NUMBER 79

BULLETIN

SUBJECT: Reinforcing of Rib Nose Structure

MODELS AFFECTED: J4 Cubs, Serial Nos. 4-400 to 4-634 incl., 4-636, 4-638, 4-639 and 4-641.

SKETCH 1

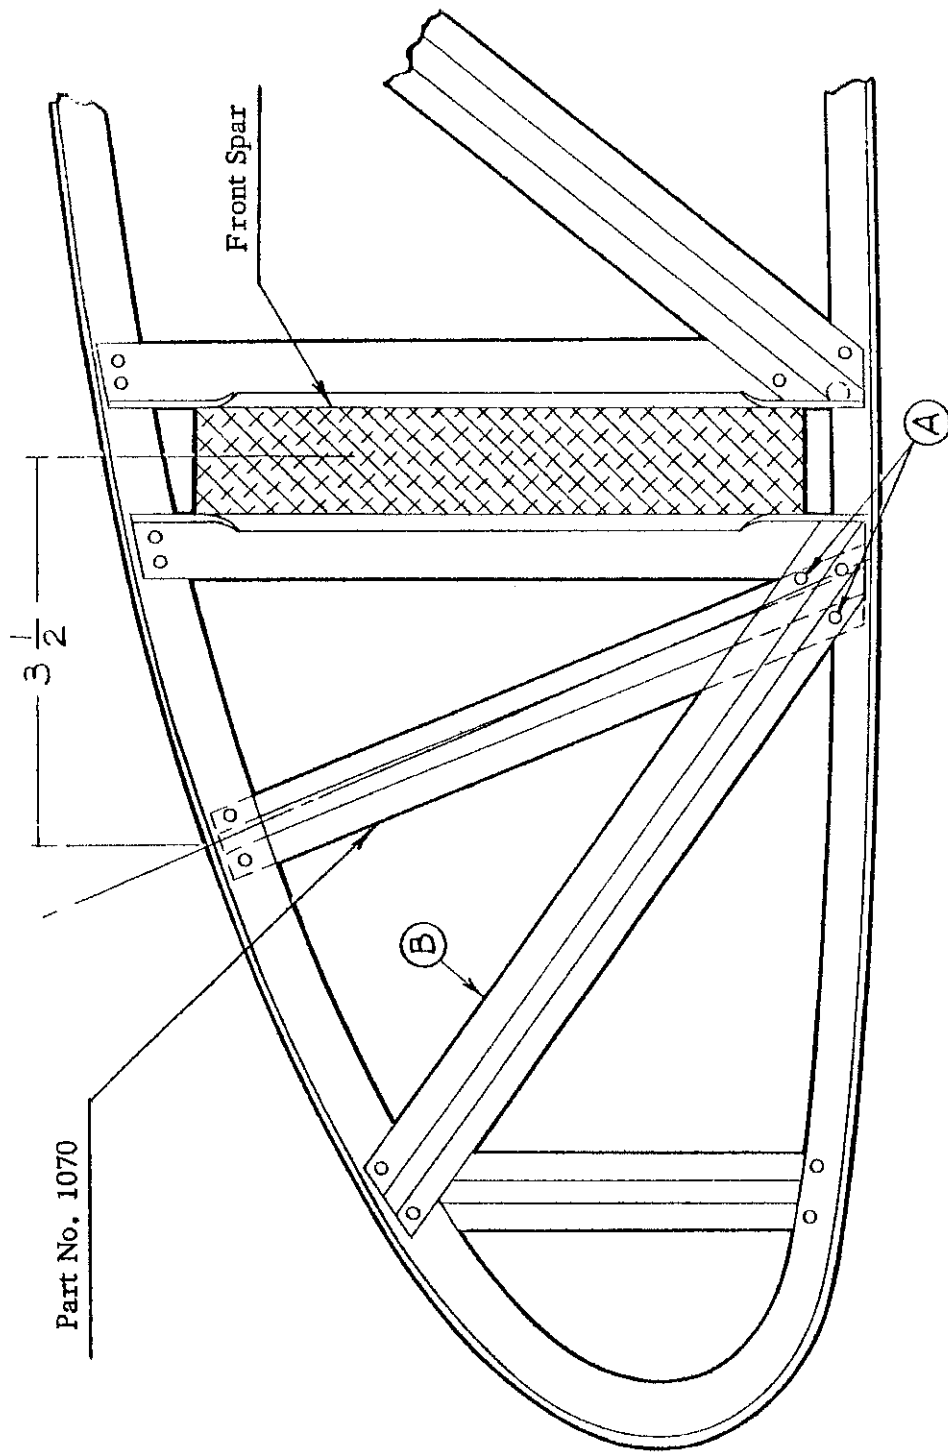
Sketch 1 shows the structure of the forward portion of the rib. That structure which is shown in solid lines is that which is now existent. The diagonal brace shown in dotted lines is to be inserted as shown.

To install this reinforcing brace, it will be necessary to remove the two rivets marked "A". These rivets are removed most easily by drilling from the hollow end with a size 42 drill. The brace is to be installed with four (4) 3/32" soft aluminum rivets, two of which replace the original rivets. The remaining two rivets are placed in the upper end of the brace as shown in the accompanying sketch.

In riveting this brace, it must be borne in mind that the minimum distance between the centerline of the rivet and the edge of the material is 1/8". Care must also be exercised not to split the capstrip when riveting in the crimped section. The material has already been worked and any careless hammering is certain to result in cracks. It is recommended that a formed heading and bucking block be used.

The reinforcing brace must be installed on the opposite side of the rib from the present diagonal, marked "B" on the sketch.
